**NEW YORK STATE THRUWAY AUTHORITY
DEPARTMENT OF ENGINEERING**

**AMENDMENT NO. 5
TO**

**CONTRACT TANY 26-17B
D215020
REPLACEMENT OF THE PINE HILL ROAD
BRIDGE OVER I-87 AT MP 47.58,
REHABILITATION OF I-87 BRIDGE OVER
SMITH CLOVE ROAD AT MP 47.04,
AND RESURFACING AND SAFETY IMPROVEMENTS
ON I-87 BETWEEN MP 46 AND MP 48
IN THE NEW YORK DIVISION
OF THE NEW YORK STATE THRUWAY
IN ORANGE COUNTY**

**IN THE LETTING OF
JUNE 24, 2026**

CONTRACT NUMBER:	TANY 26-17B
DATE:	01/19/2026
DRAWING NUMBER:	TC-03

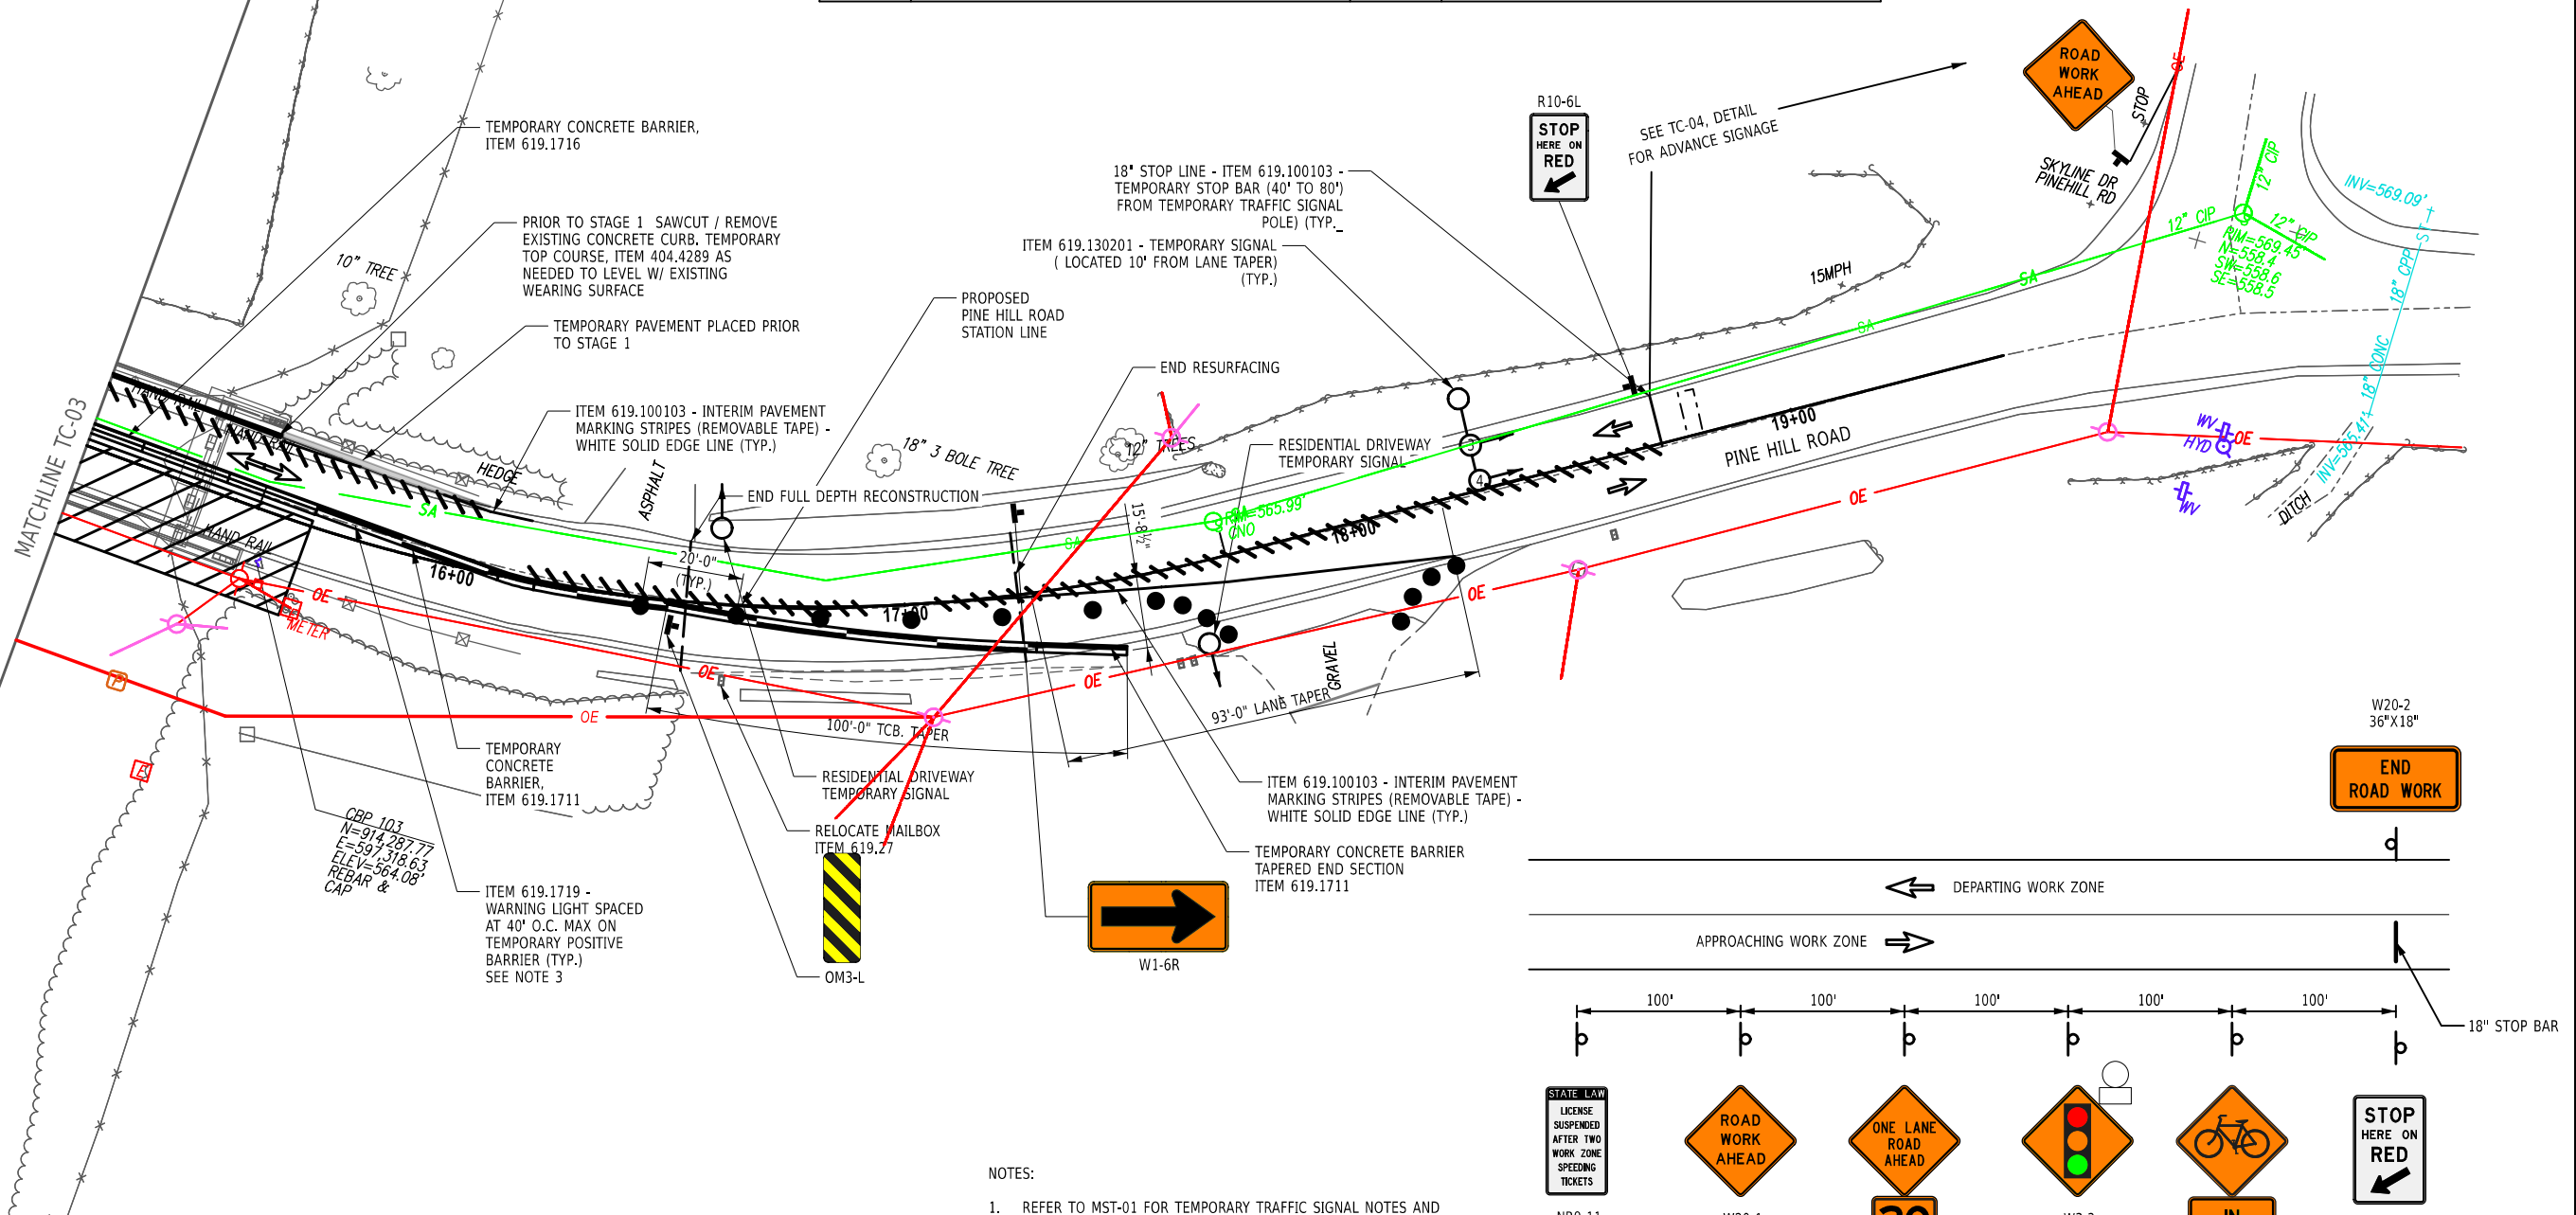
3. **DELETE** Drawing Number TC-03, Sheet 11 of 180, and **SUBSTITUTE** with the attached Drawing Number TC-03, Sheet 11A5 of 180. The drawing has been revised as follows: in the Legend and detailed drawing, any previous callouts to Item 619.1715, Temporary Positive Barrier – Category 5 (Pinned Prohibited) 20’ Long have been changed to Item 619.1711, Temporary Positive Barrier – Category 1 (Pinned Prohibited) 20’ Long, instead. A callout to Item 619.1716, Temporary Positive Barrier – Category 6 (Pinned Required) 20’ Long is now shown along the median of the Pine Hill Road structure.

TITLE OF PROJECT
REPLACEMENT OF THE PINE HILL ROAD
BRIDGE AT I-87 MILEPOST 47.58
LOCATION OF PROJECT
VILLAGE OF WOODBURY
ORANGE COUNTY BIN 5514280
TITLE OF DRAWING
STAGE CONSTRUCTION
SECTIONS
(1 OF 2)

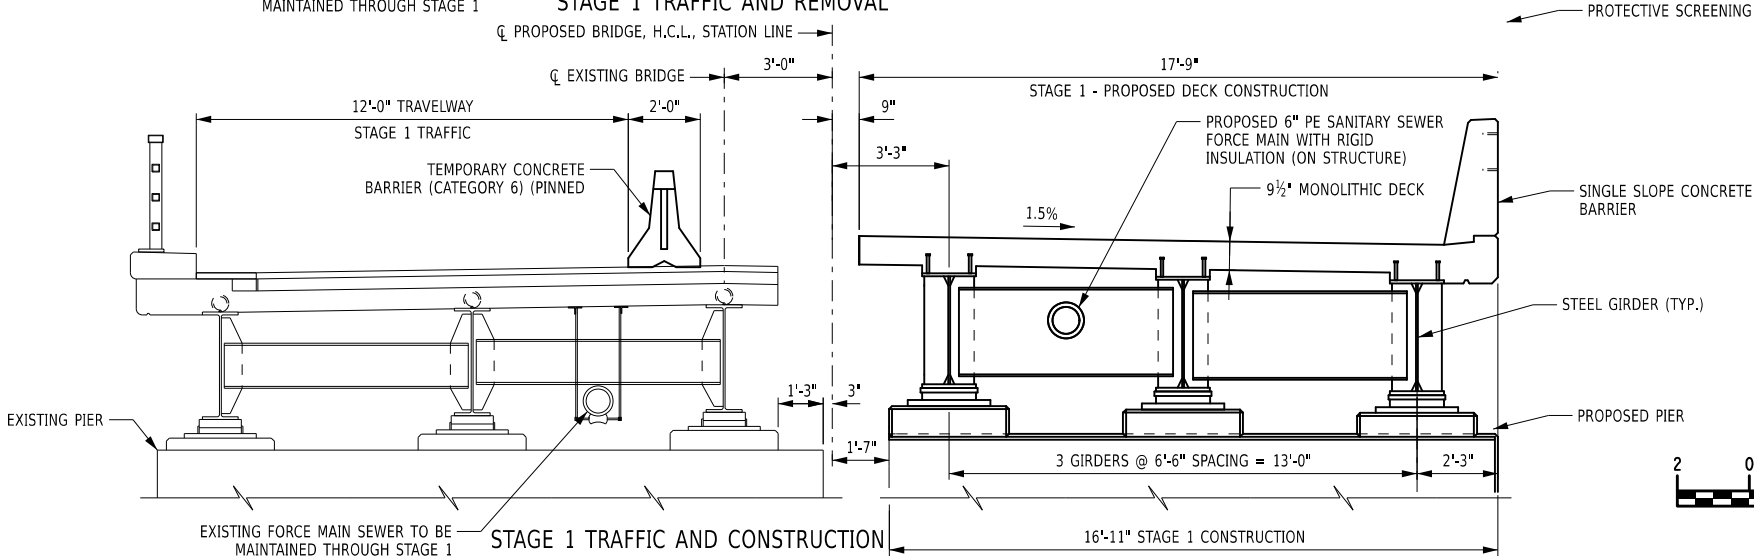
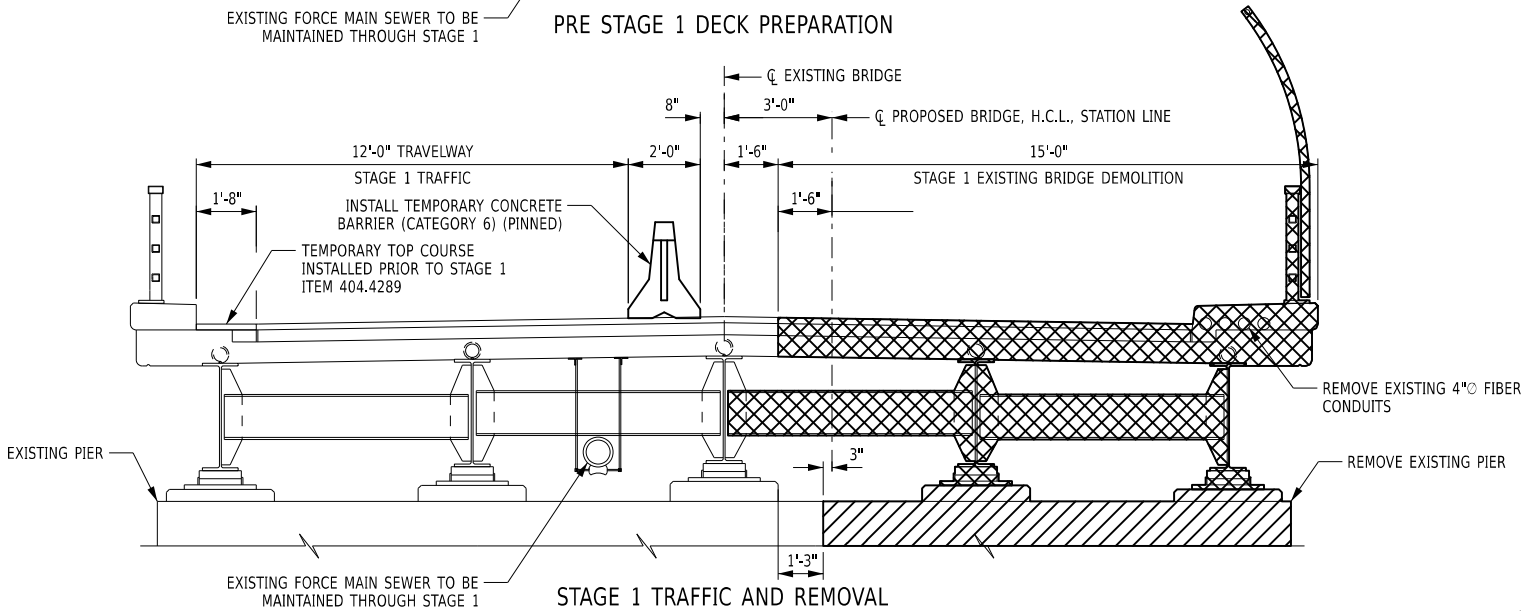
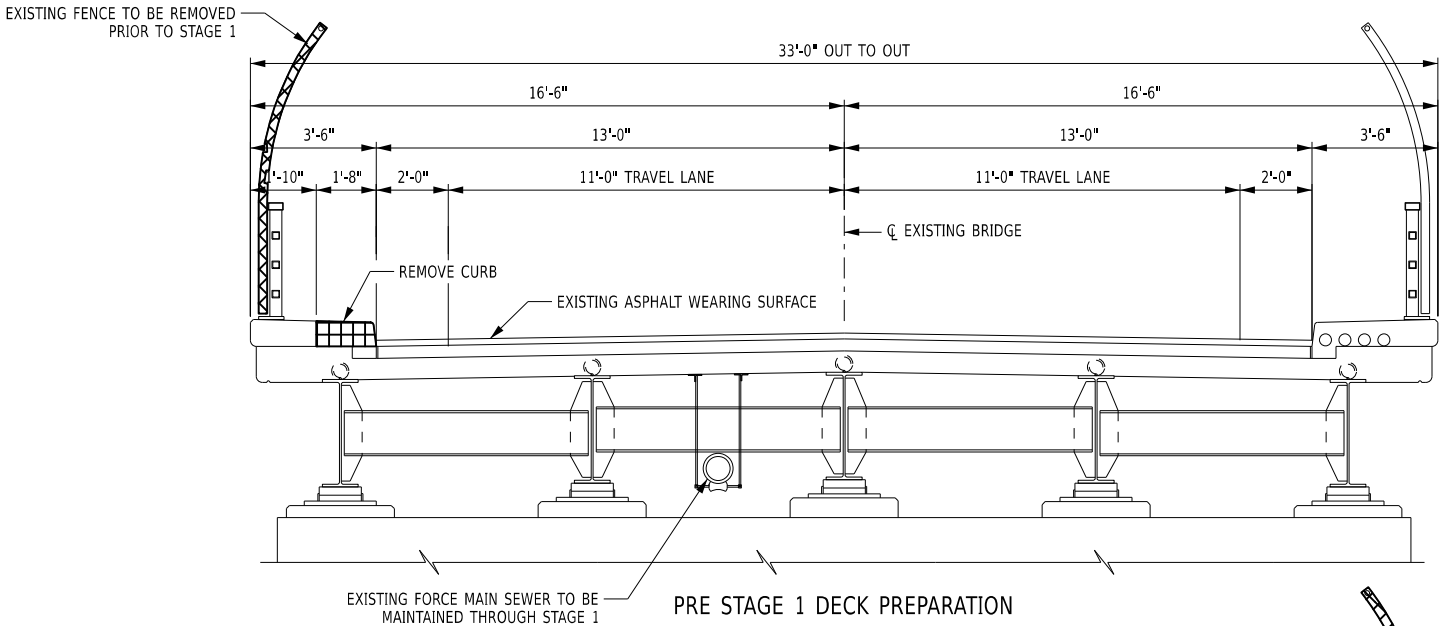
5. **DELETE** Drawing Number ST-05, Sheet 45 of 180, and **SUBSTITUTE** with the attached Drawing Number ST-05, Sheet 45A5 of 180. The Stage 1 Traffic and Construction detail in the bottom of the drawing has been updated. The temporary positive barrier with the box beam attached to it as shown on the Stage 1 proposed deck construction has been removed.

Thruway Authority	TITLE OF PROJECT I-87 BRIDGE REHABILITATION, OVER SMITH CLOVE ROAD (MP 47.04)	CONTRACT NUMBER: TANY 26-17B
	LOCATION OF PROJECT VILLAGE OF WOODBURY, ORANGE COUNTY BIN 5514279	DATE: 05/21/2025
	TITLE OF DRAWING EXISTING TYPICAL BRIDGE & ROADWAY SECTIONS	DRAWING NUMBER: ETS-1

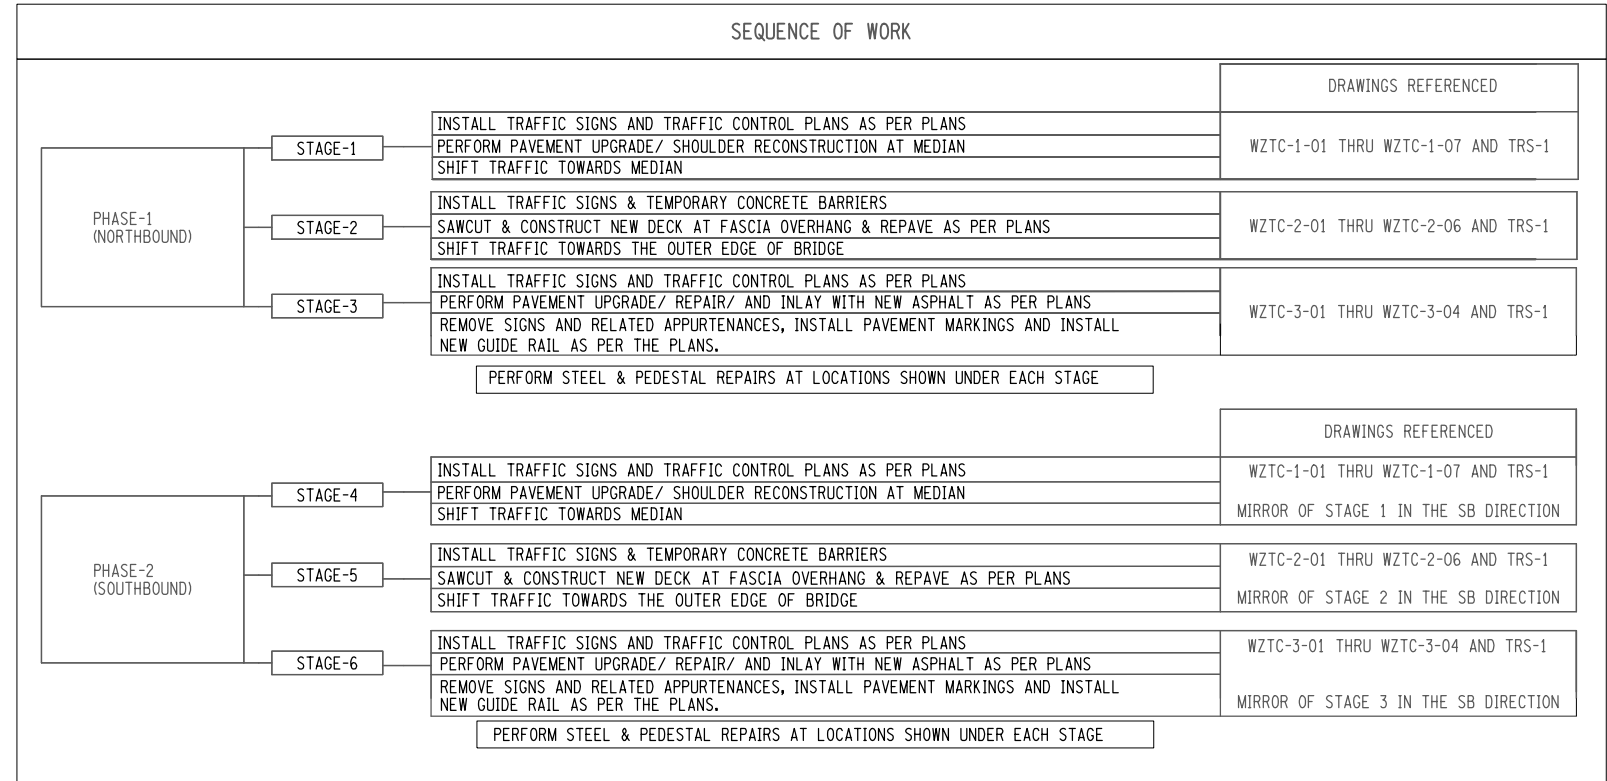
6. **DELETE** Drawing Number ETS-1, Sheet 115 of 180, and **SUBSTITUTE** with the attached Drawing Number ETS-1, Sheet 115A5 of 180. In the Typical Section: Smith Clove Road Under I-87 Bridge – Existing detail, the text “(BOTH SIDES)” in the Temporary Positive Barrier callout has been removed.

CONTRACT NUMBER:
TANY 26-17B
DATE:
05/21/2025
DRAWING NUMBER:
WZTC-1-01

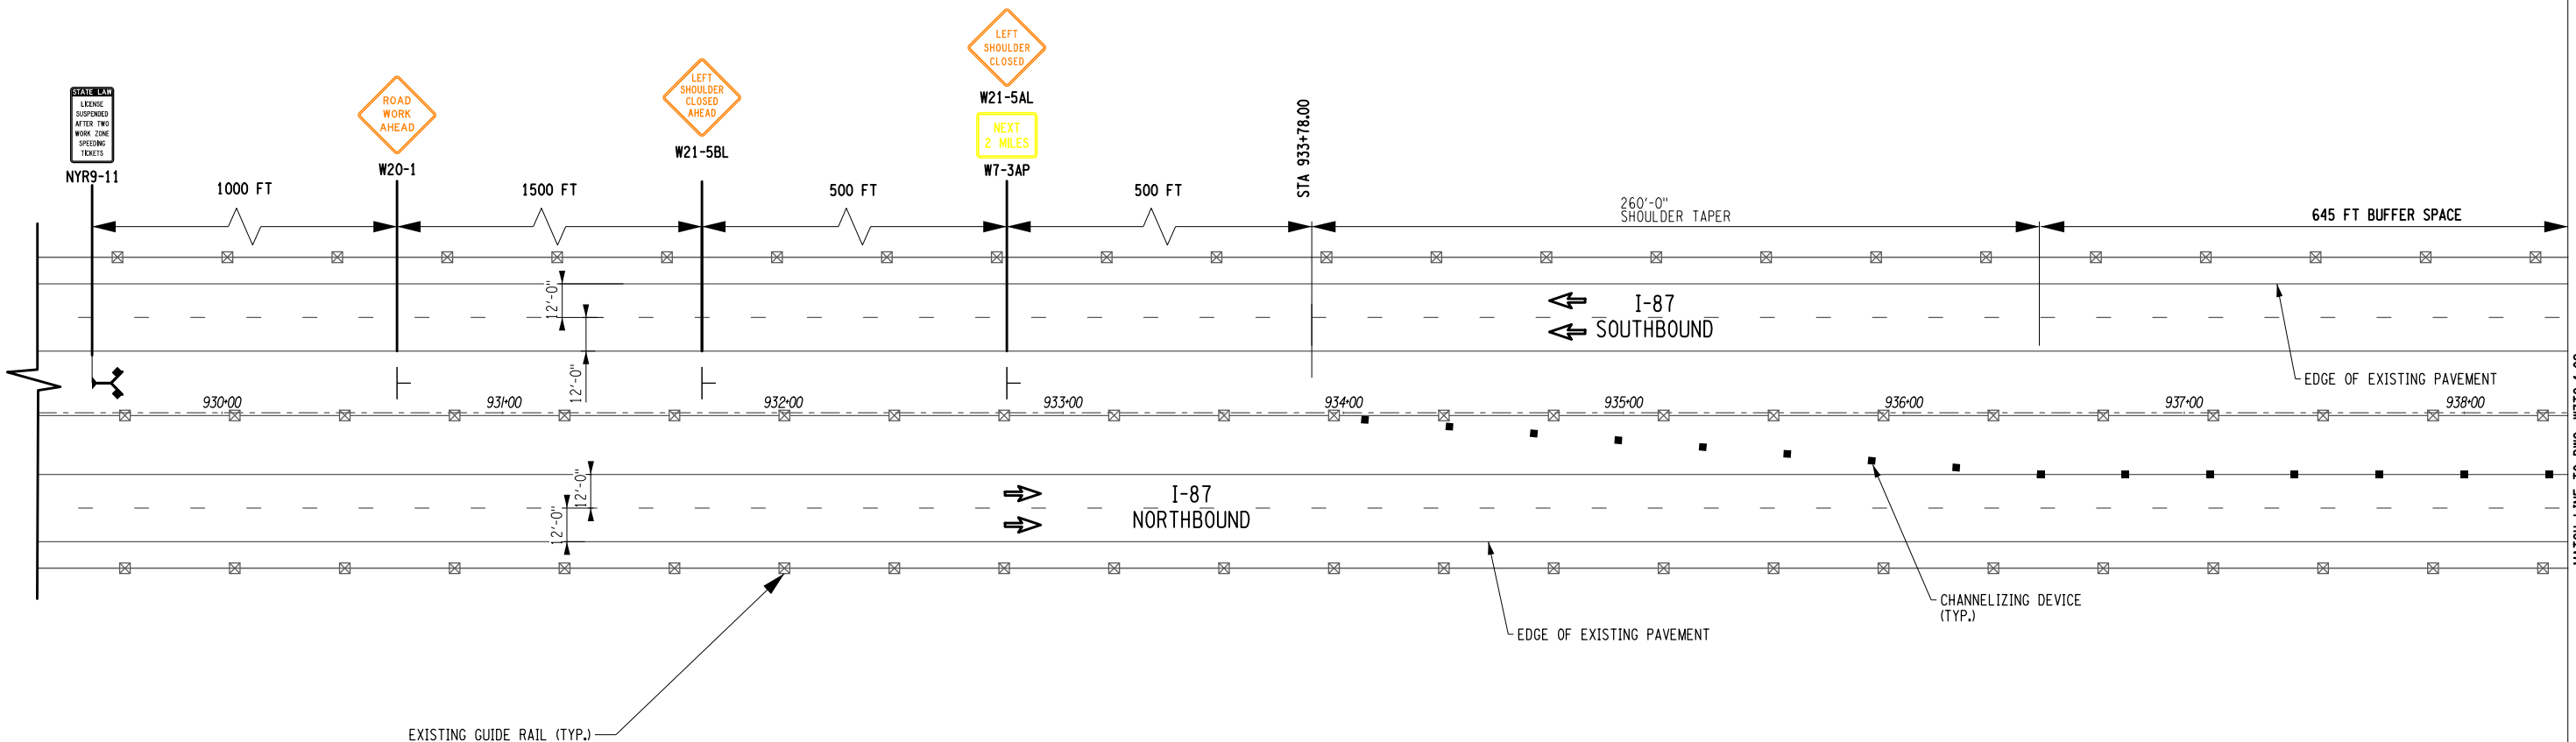
8. **DELETE** Drawing Number WZTC-1-01, Sheet 117 of 180, and **SUBSTITUTE** with the attached Drawing Number WZTC-1-01, Sheet 117A5 of 180. A printing error affecting line styles for Temporary Concrete Barrier, channelizers, and sediment filter logs have been corrected. In the Legend the prospective bidder is to revise any previous reference in the drawing for Item 209.2301, Sediment Filter Log Temporary, 12" to read as Item 209.1311, Sediment Filter Log - Temporary, 12", Type A, instead.
